Sedgwick Reserve Electrical Utility Relocation
Project No. FM130513S/986150
Addendum No. 3

ADDENDUM No. 3

SINGLE LINE DIAGRAM

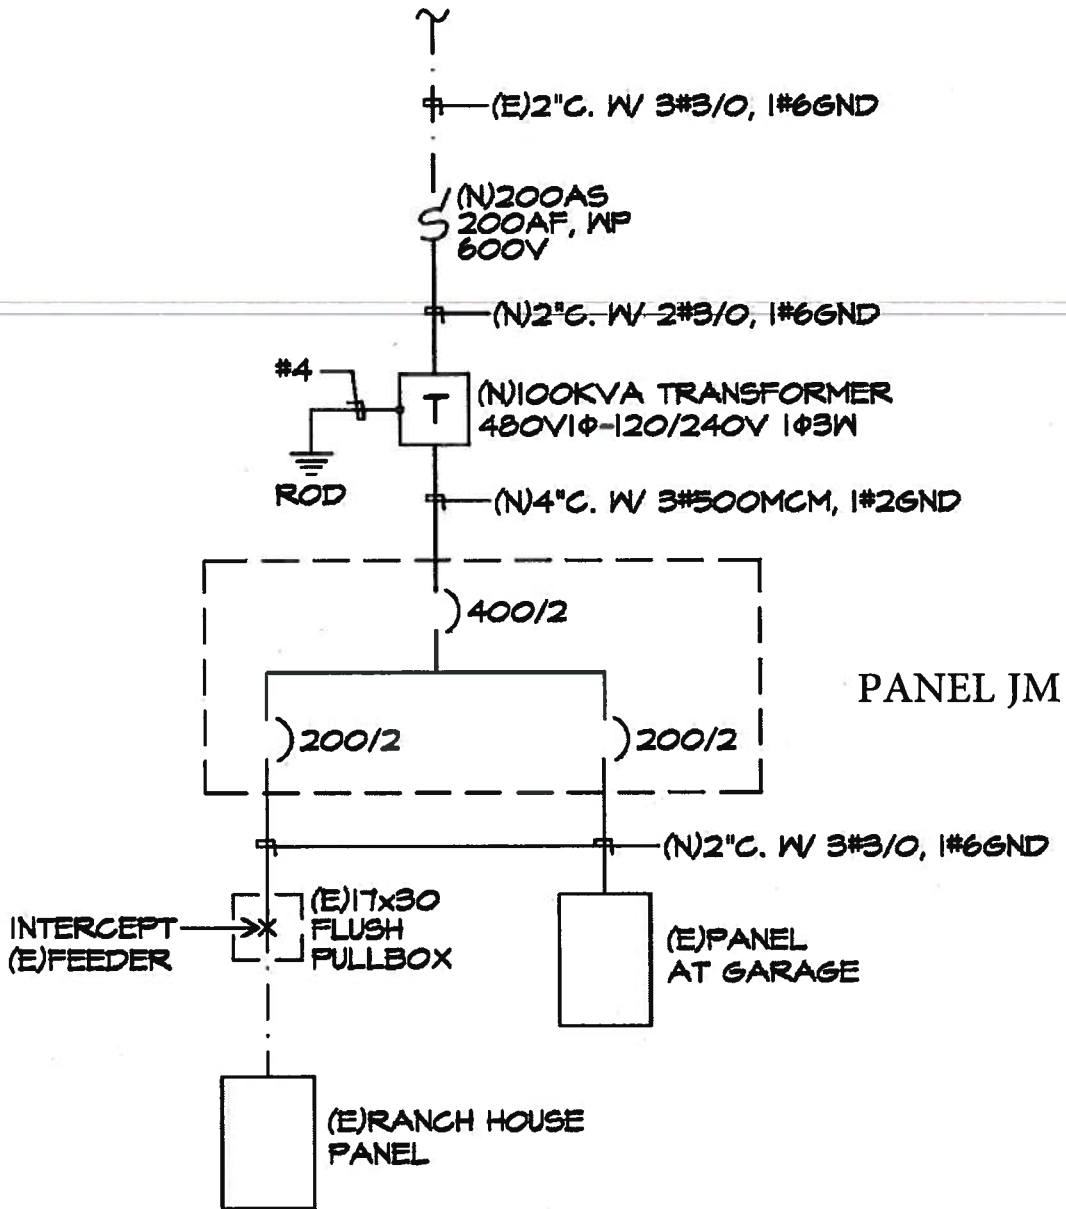
ADD to DRAWING NO. E-4 (ELECTRICAL SITE PLAN): “SKE -1, Single Line Diagram, Panel “JM”, dated 10-23-13”, see attached SKE-1.
